ADDENDUM #2:

DATE: April 9, 2026

JOB: FTCC - HTC Building – 1<sup>st</sup> Floor Surgical Lab Renovation; APN 2523

**2 DEMOLITION FLOOR PLAN**  
1/8" = 1'-0"

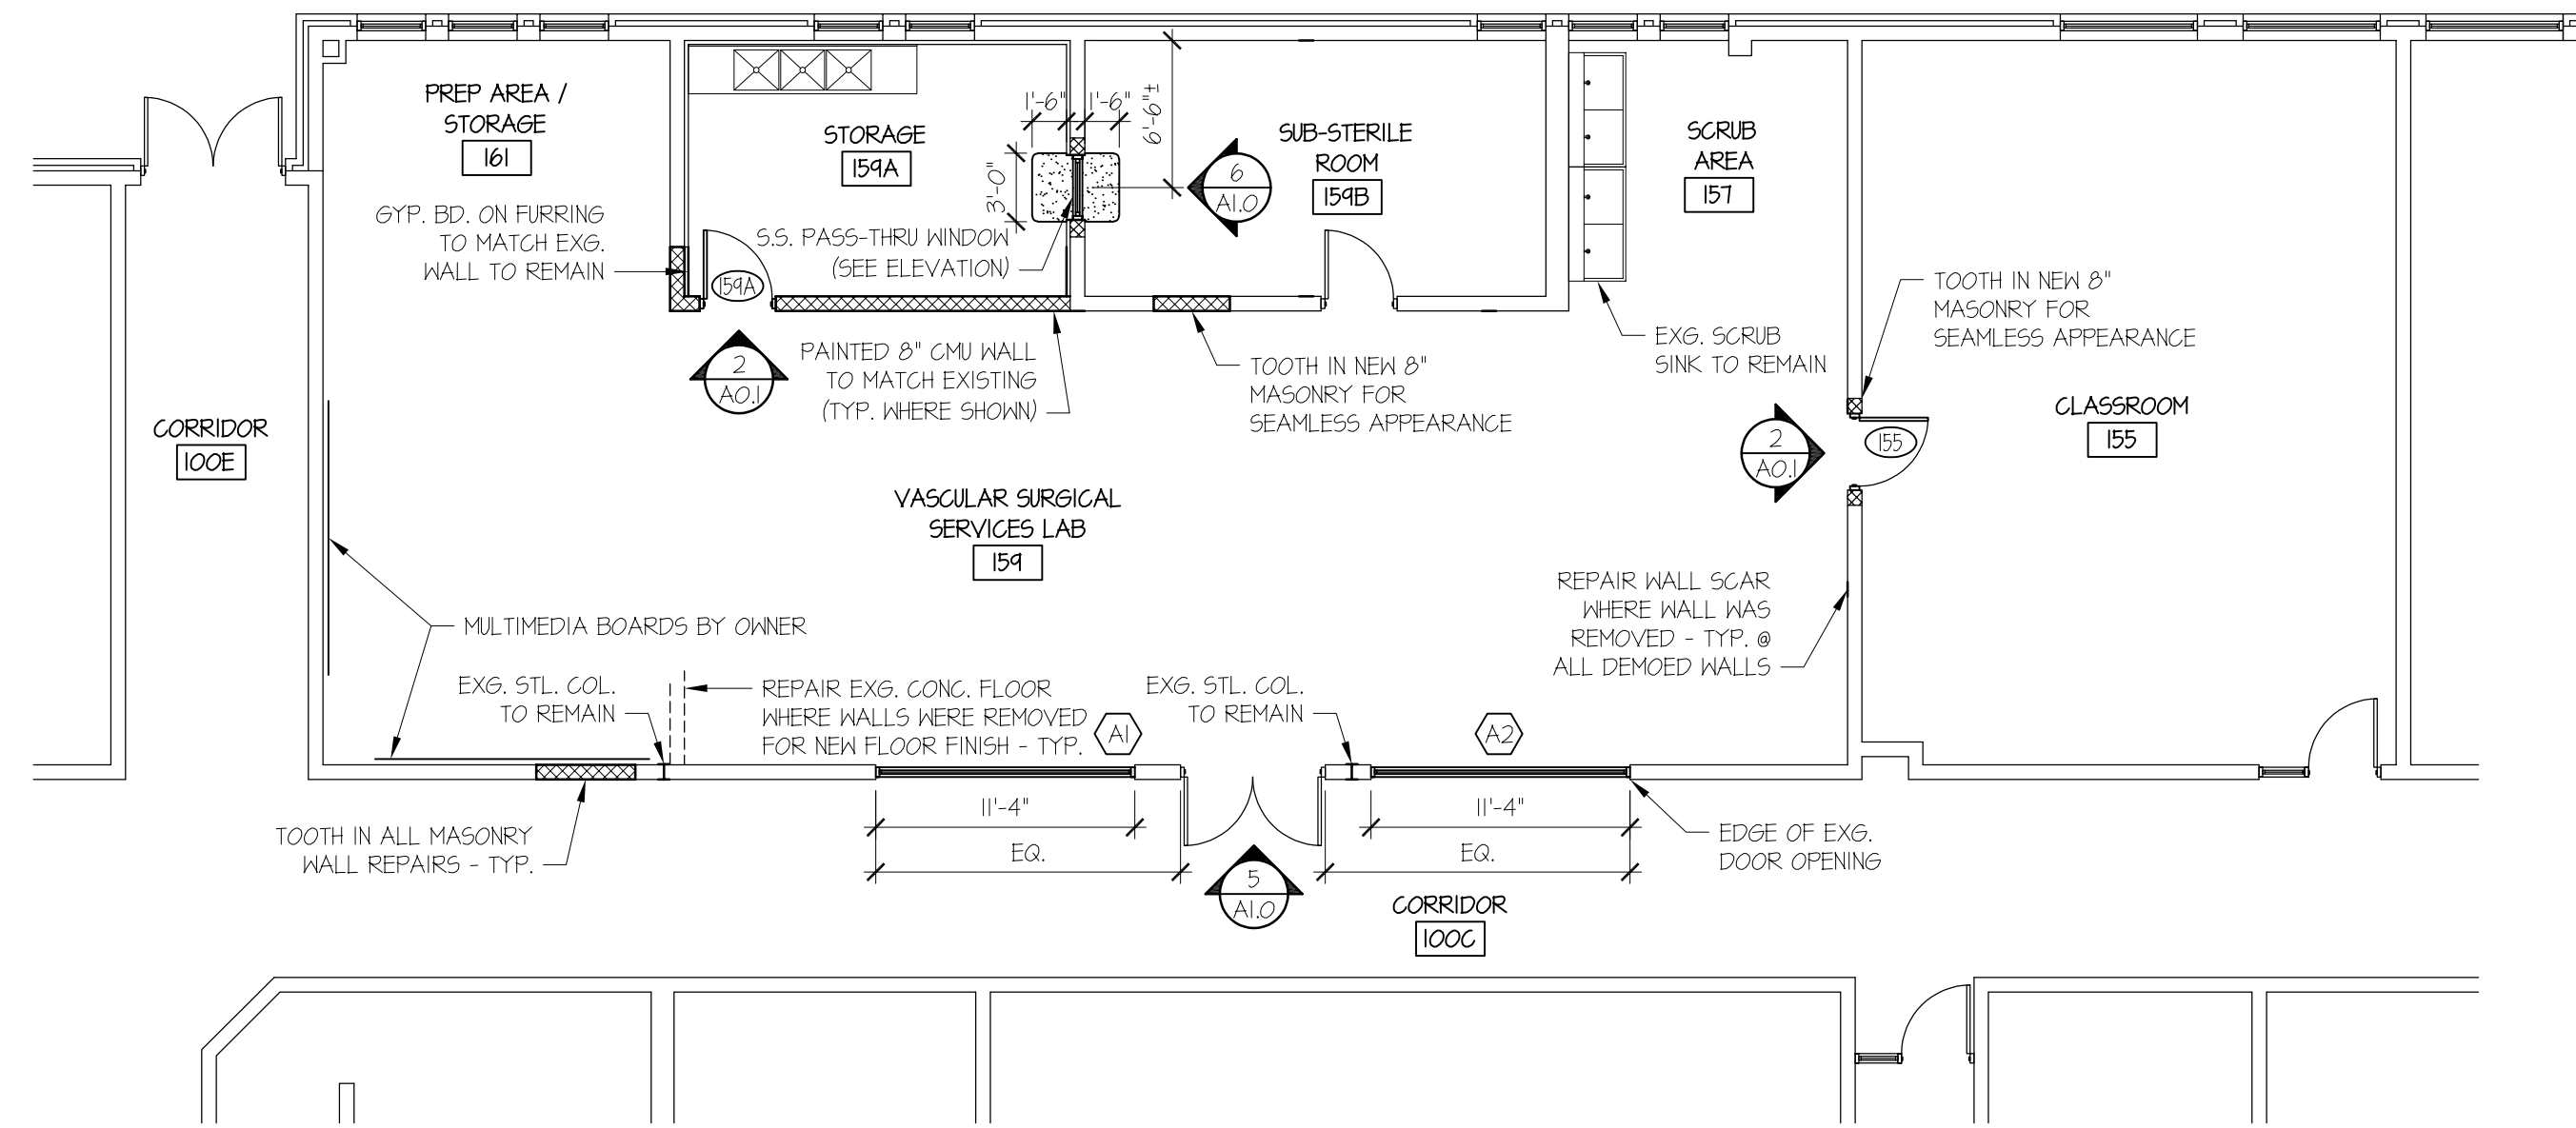
- 1) The temporary wall described on the demolition plan will need to be constructed from non-flammable material similar to metal studs and gypsum board. The temporary wall door accessing the space behind the wall may be constructed of any material.
- 2) The masonry walls described “to be removed” on the demolition plan are assumed to be sitting on the concrete floors (not embedded in the floor cavity. Should it be discovered otherwise, the concrete floor repair costs will be negotiated using the contingency allowance.
- 3) The existing fire alarm system is by Edwards Fire Alarm Systems. There is no plan for new devices just relocating two of the existing smoke detectors. FTCC will assist the contractor setting the fire alarm in “test mode” each time the contractor works in the space.

**8 SECTION @ CORRIDOR WINDOW**  
3/4" = 1'-0"

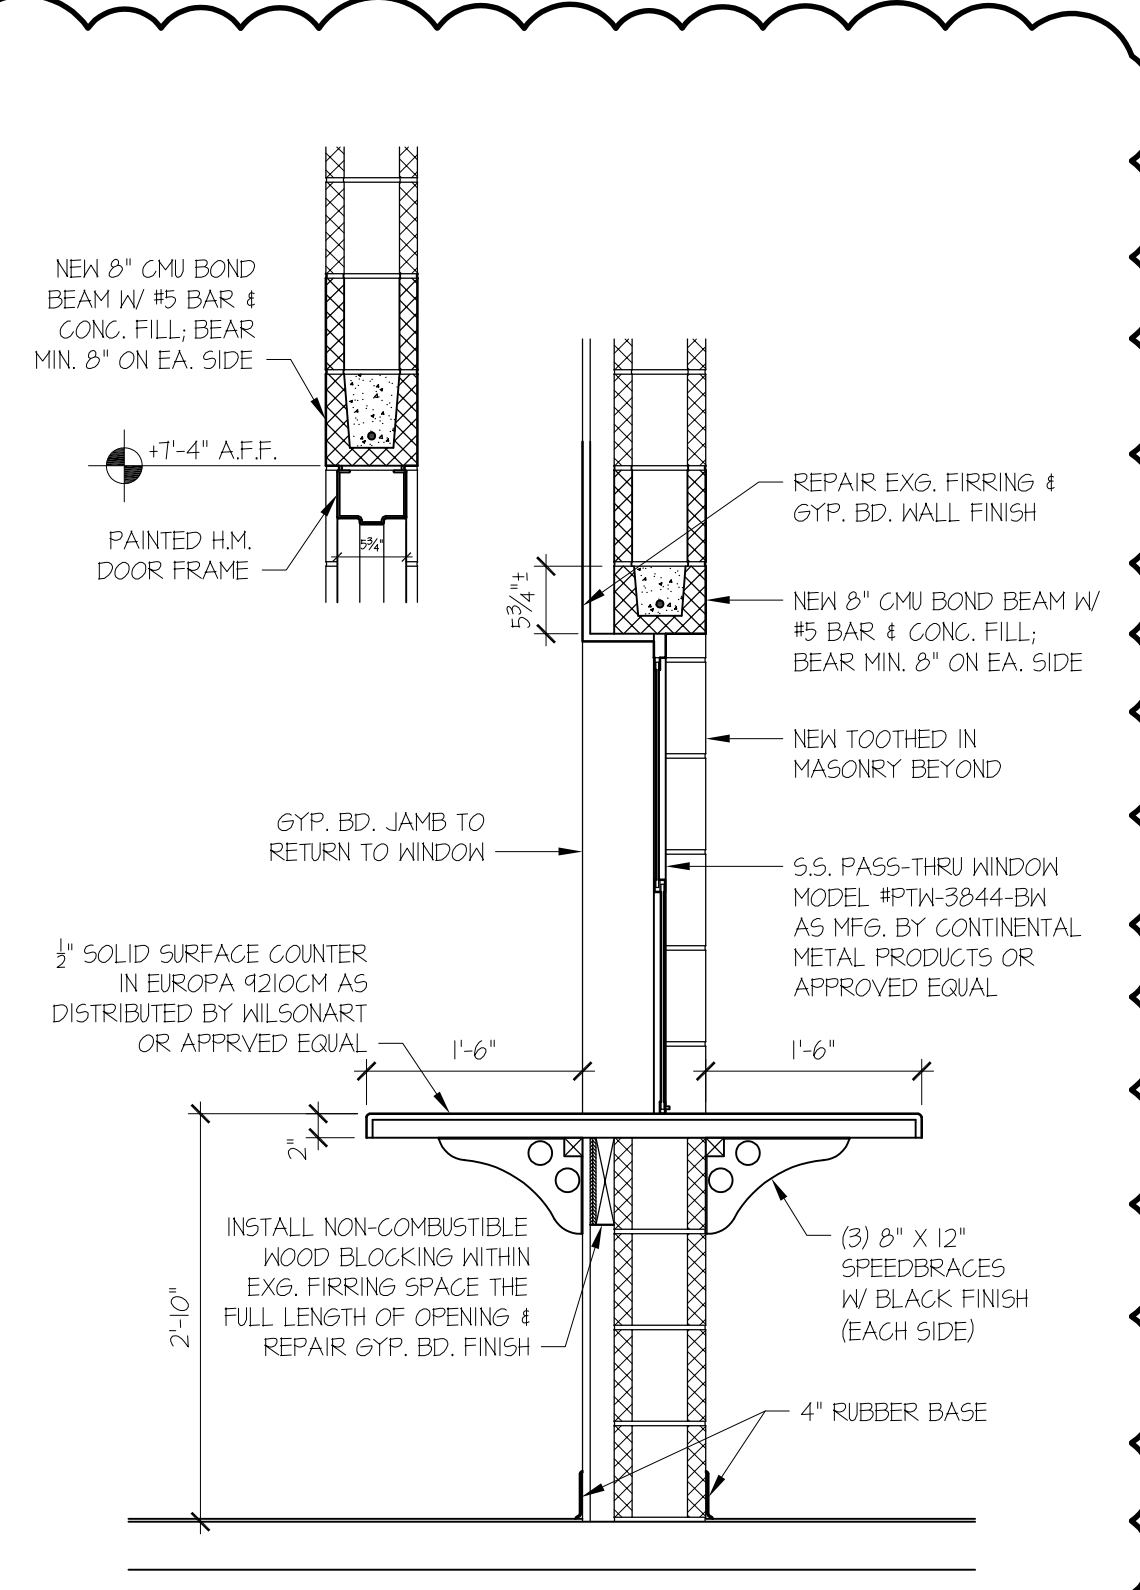
- 1) Sheet A1.0: Drawing Details 5 & 8/A1.0; the storefront base shown on these details has been changed to 4 ½” square anodized aluminum tube with the window frame sitting on top of this base. The base material should be provided by the storefront window supplier. The storefront window jambs against the masonry walls should also be of same material described by the note on detail 8/A1.0 (see attached revised drawing sheet)
- 2) Sheet A1.0: Drawing Detail 7/A1.0; the solid surfacing material described in this detail shall be Wilsonart 9210CM Europa or approved equal (see attached revised drawing sheet).
